ADDENDUM NO. 3

RE: Downtown East Drainage Improvements – City of Stuttgart, Arkansas

ADDENDUM DATE: April 19, 2024

Sheets Revised: The following plans sheets have been revised and are attached to this addendum. These sheets are to be replaced in the overall sheet set. **Sheets 45-47 & 50-57.**

STORM PLAN
 3RD STREET

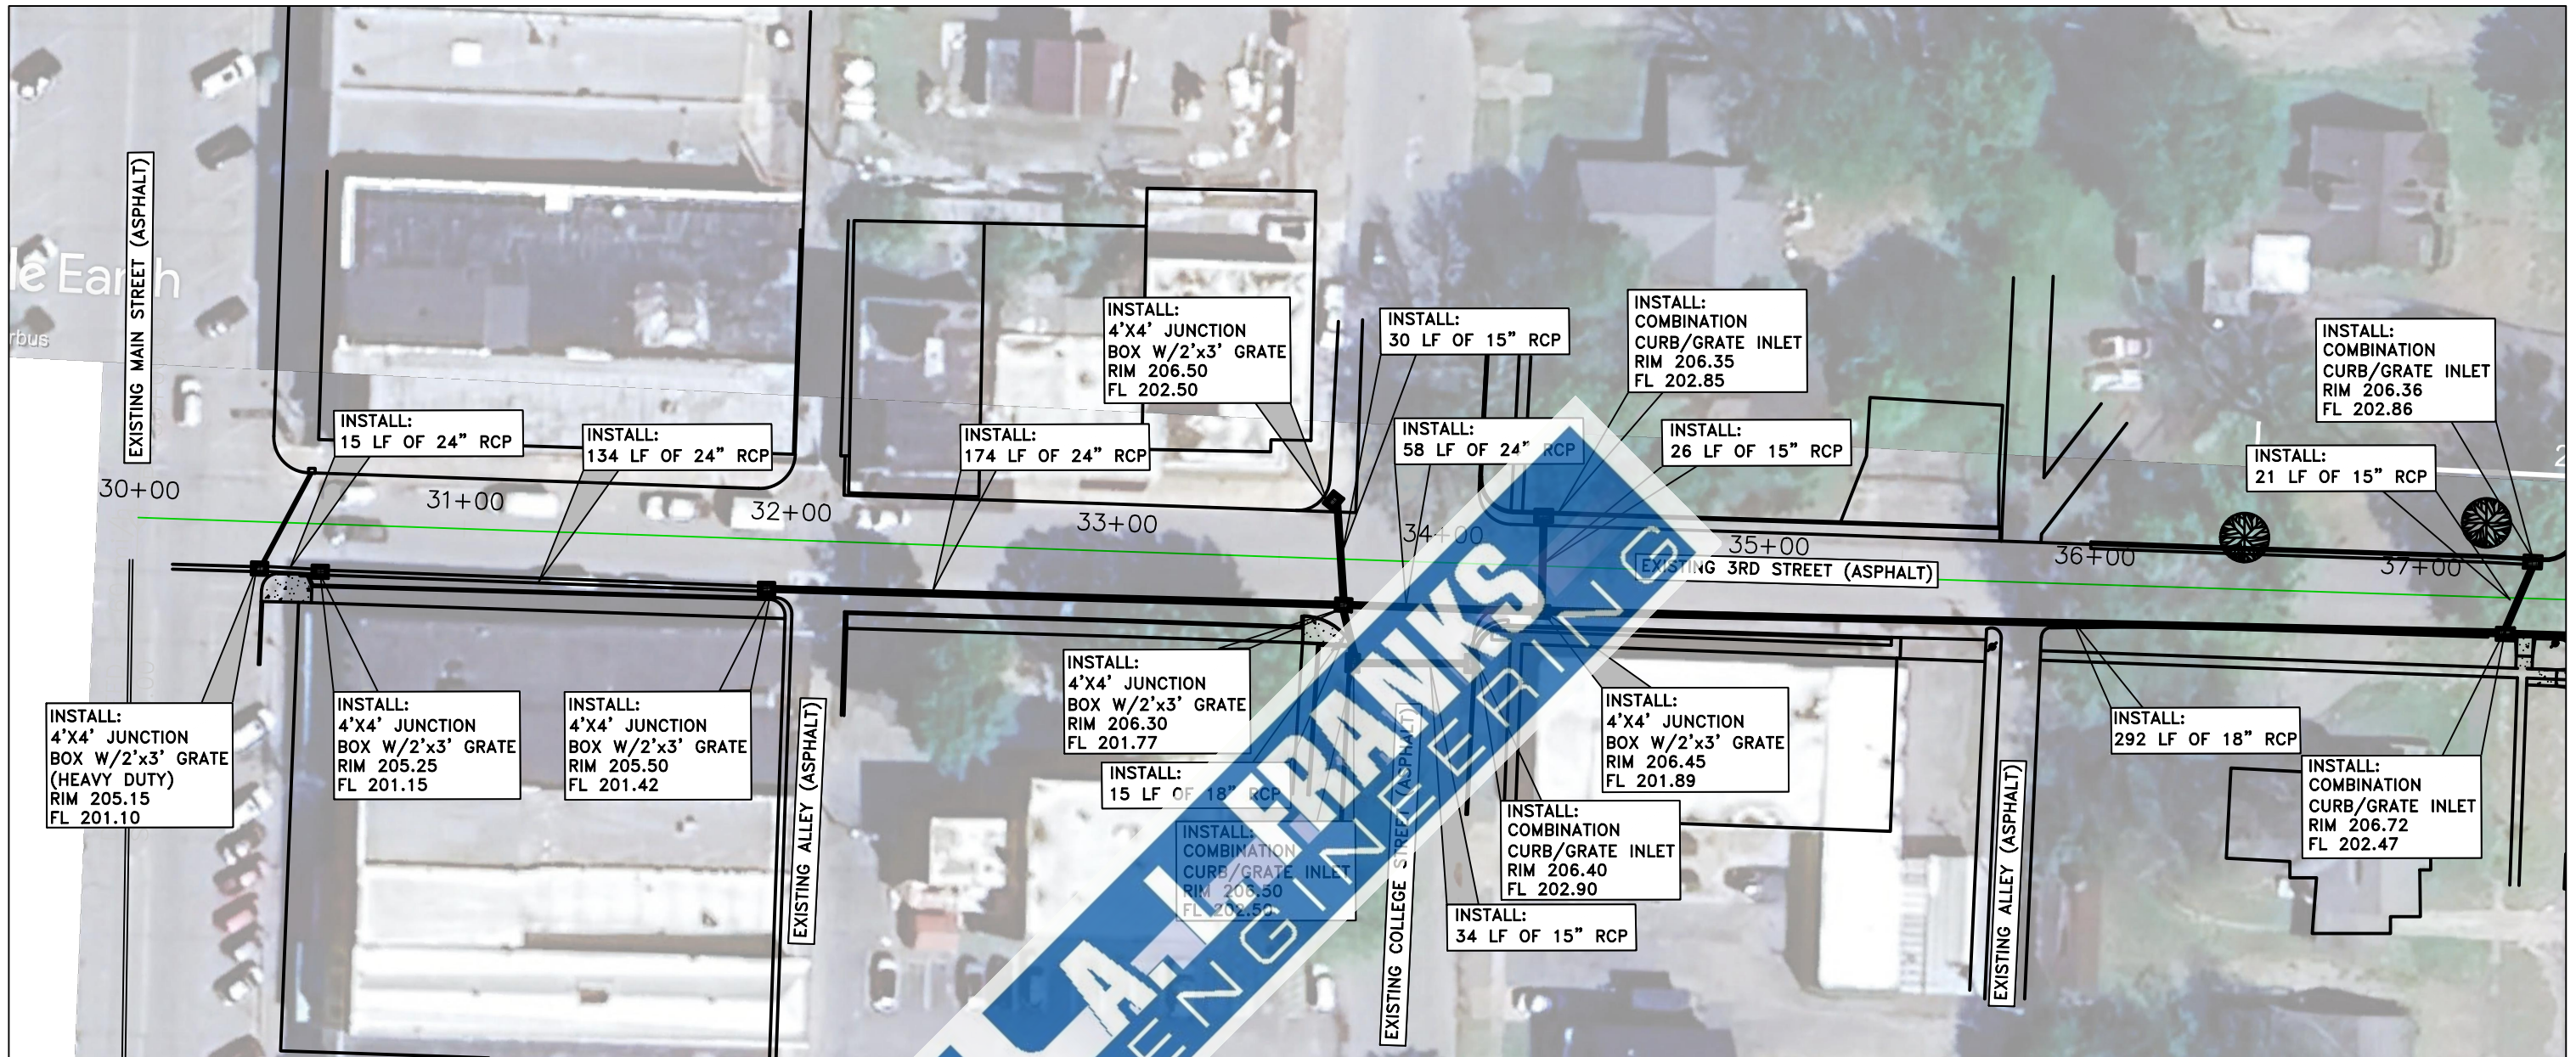
Date	Revision	By
4/18/24	1-Additional elevation data added	CJM

STORM PLAN
 3RD STREET

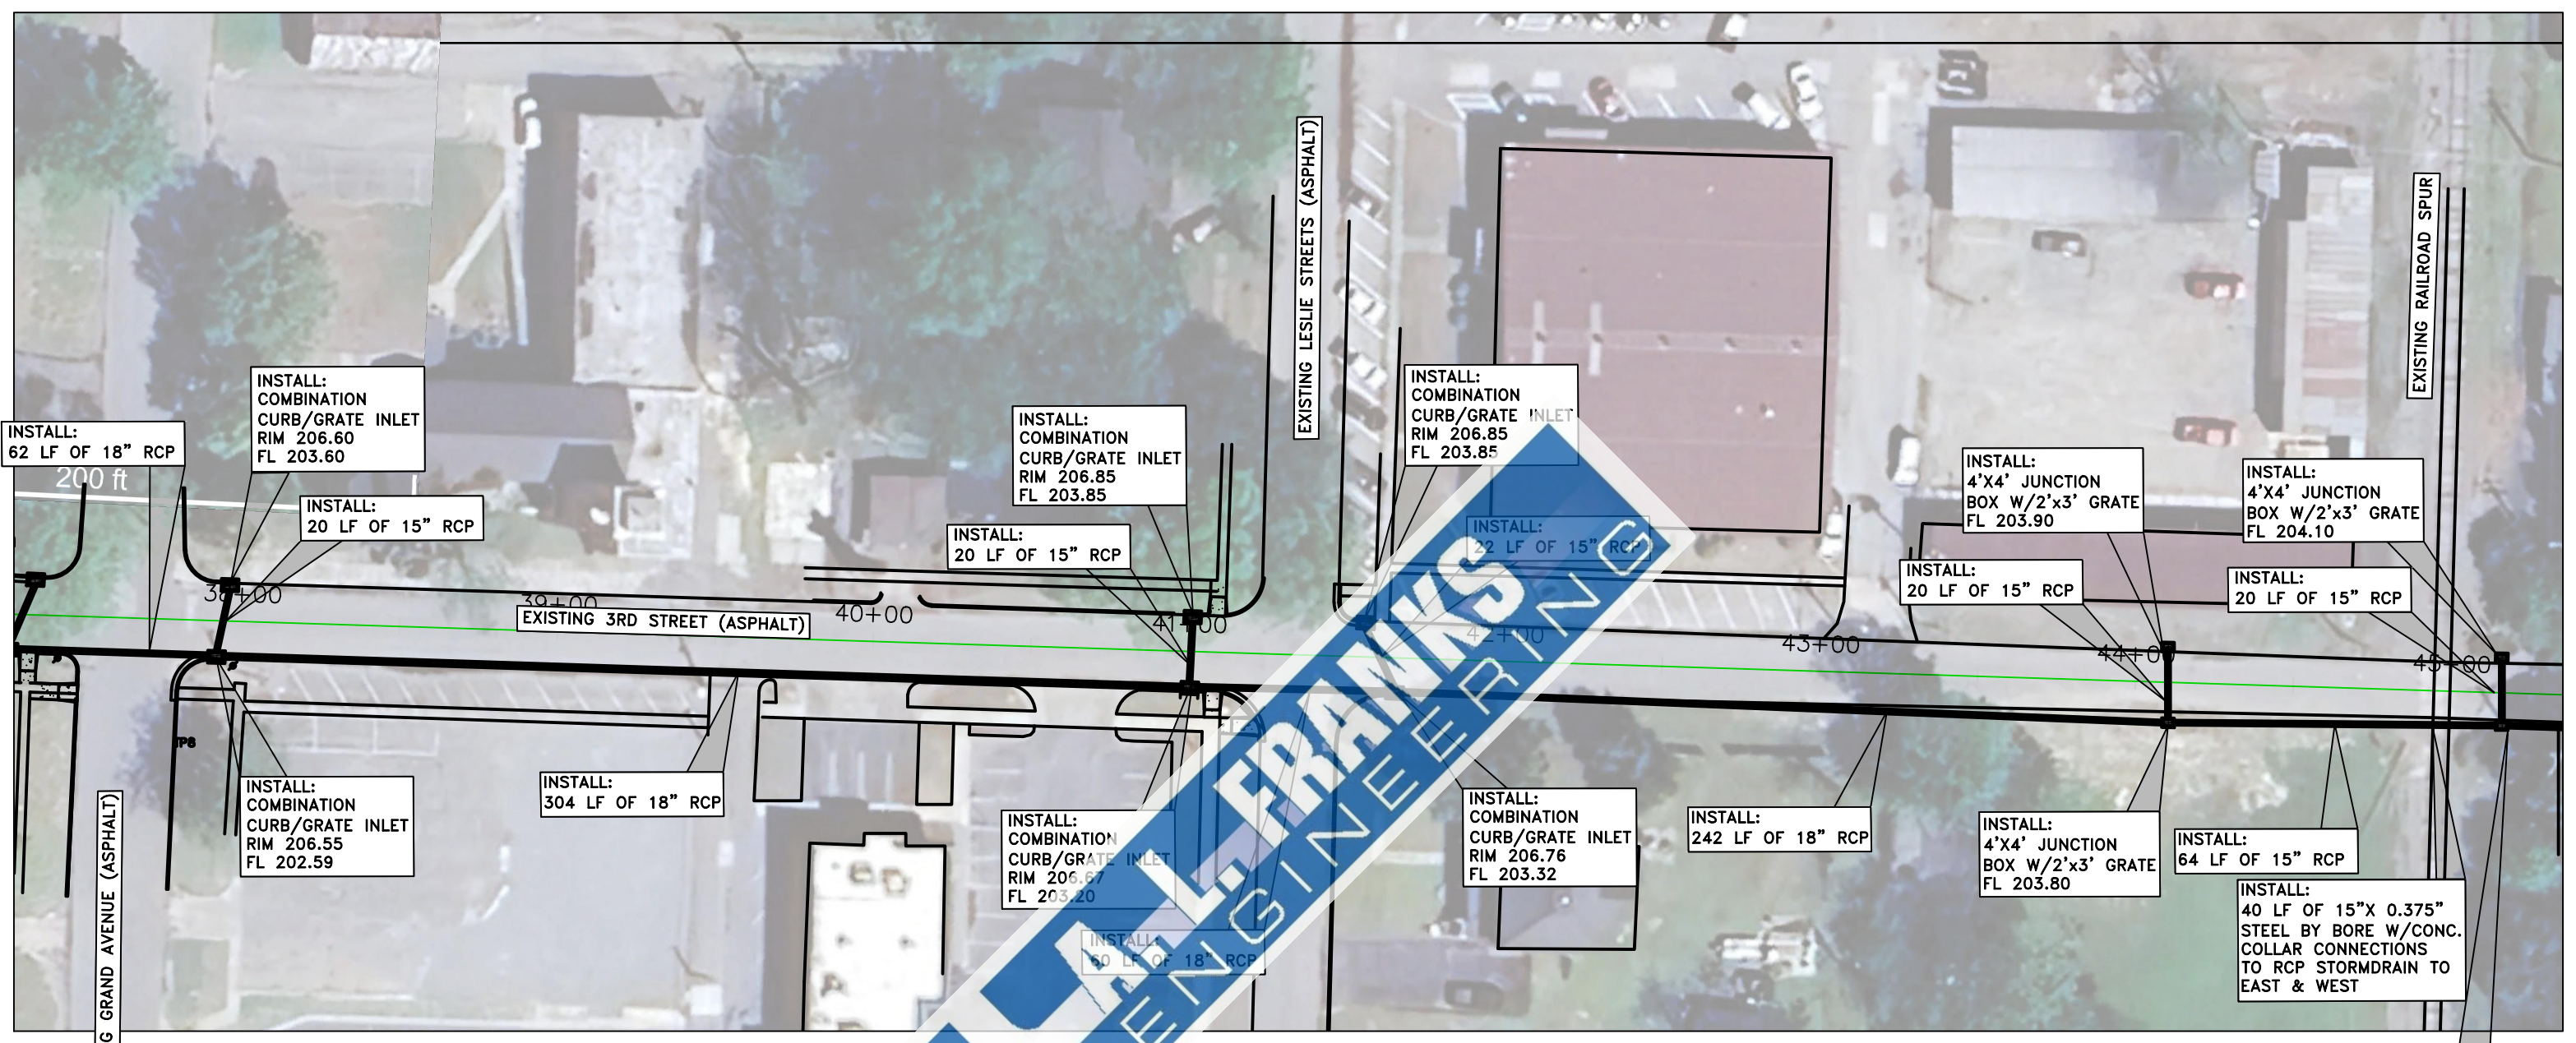
Date	Revision	By
4/18/24	1-Additional elevation data added	CJM

SITE PLAN
 3RD STREET

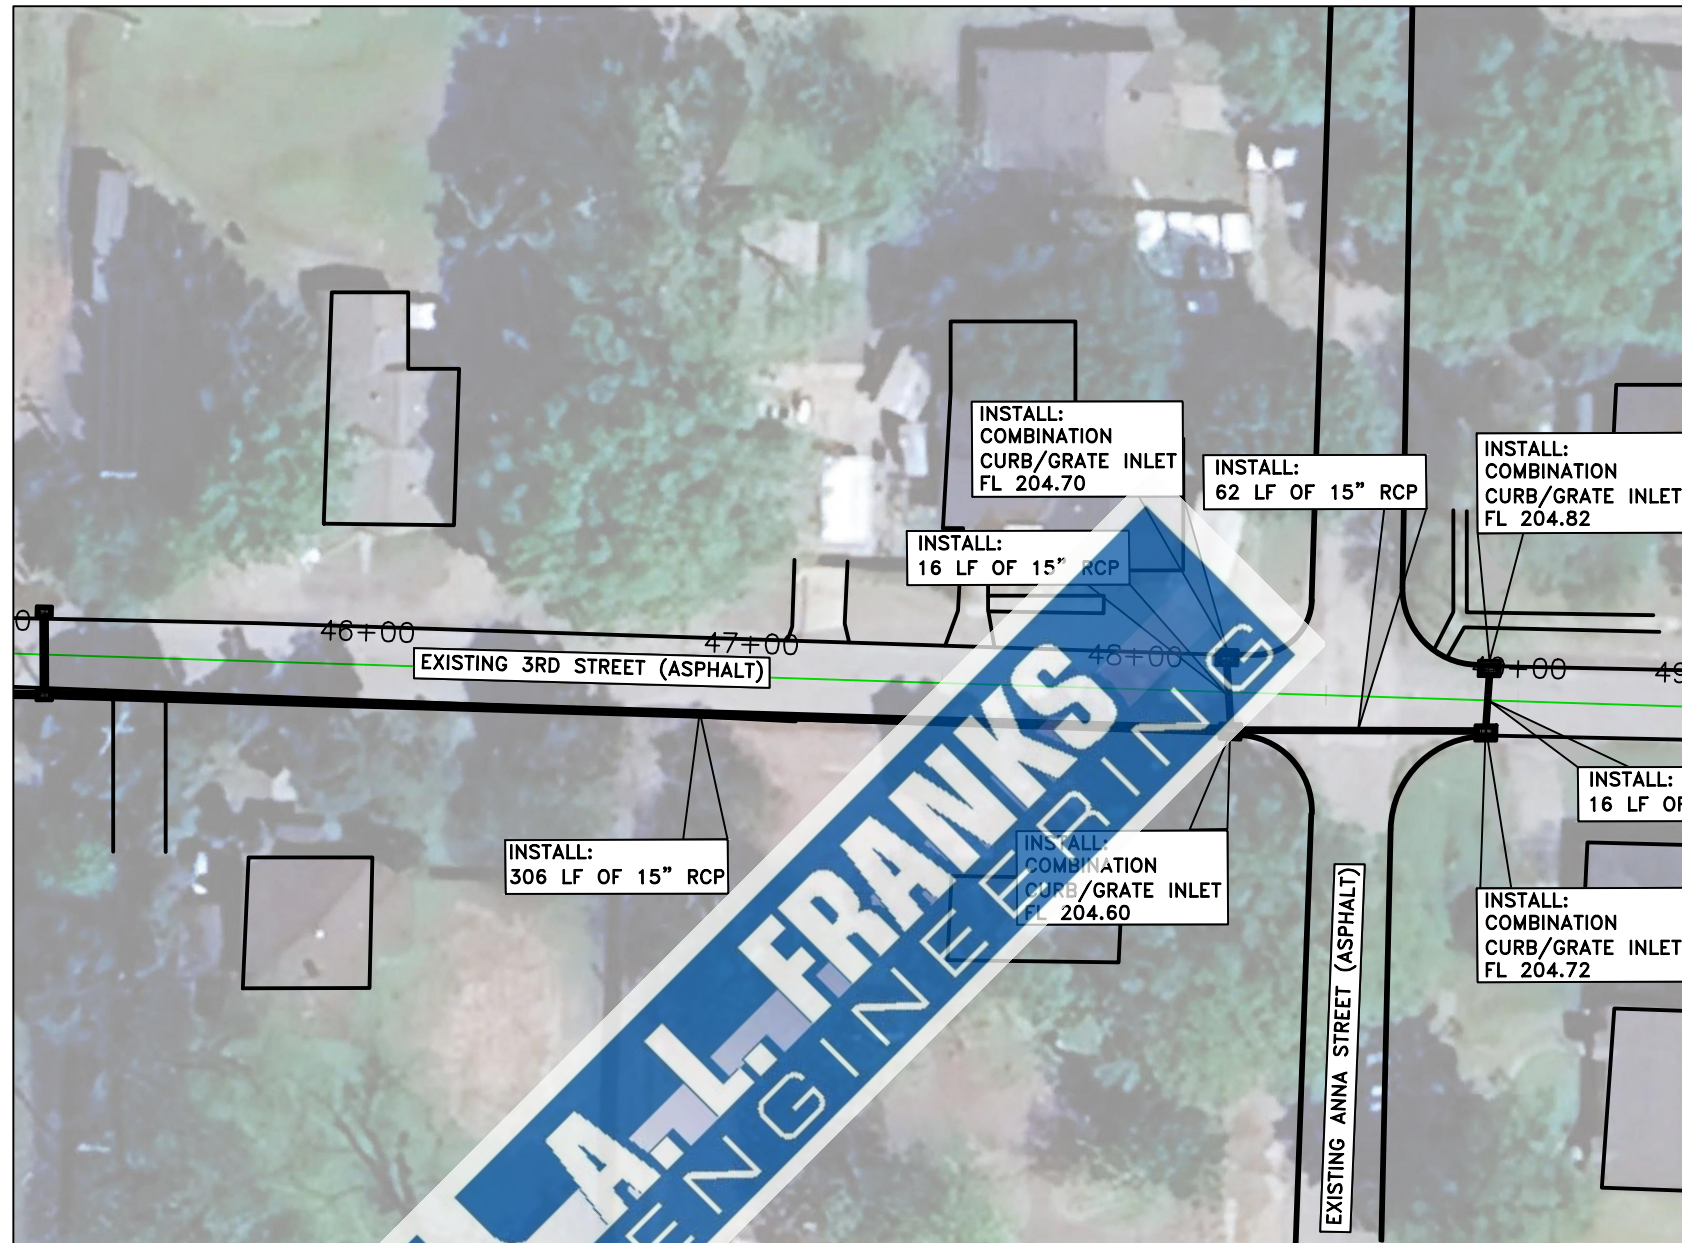
Date	Revision	By
4/18/24	1-Additional elevation data added	CJM

STORM PLAN
 5TH STREET

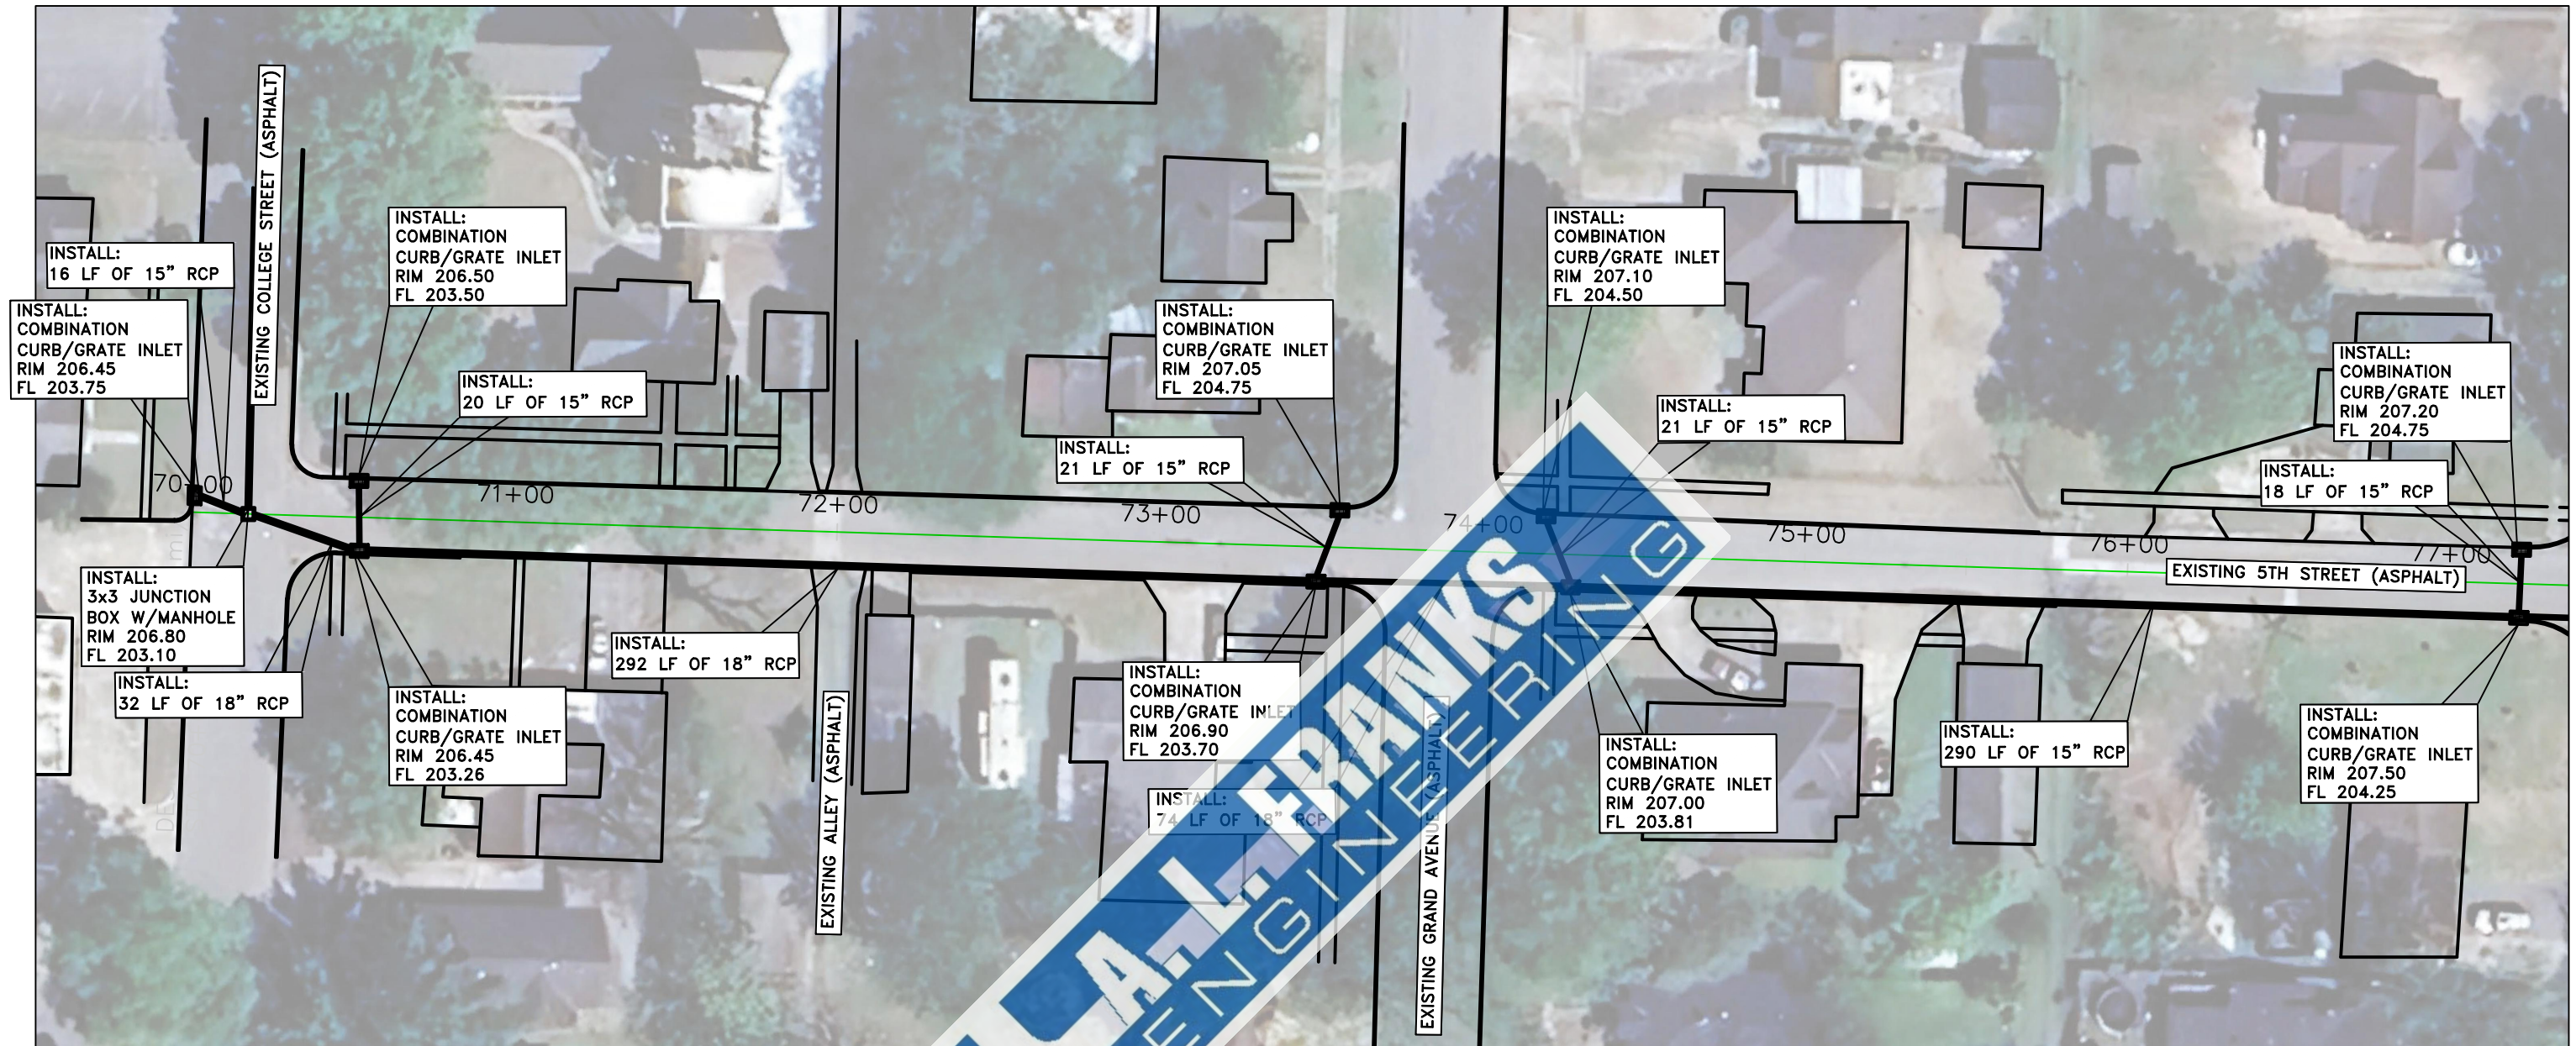
Date	Revision	By
4/18/24	1-Additional elevation data added	CJM
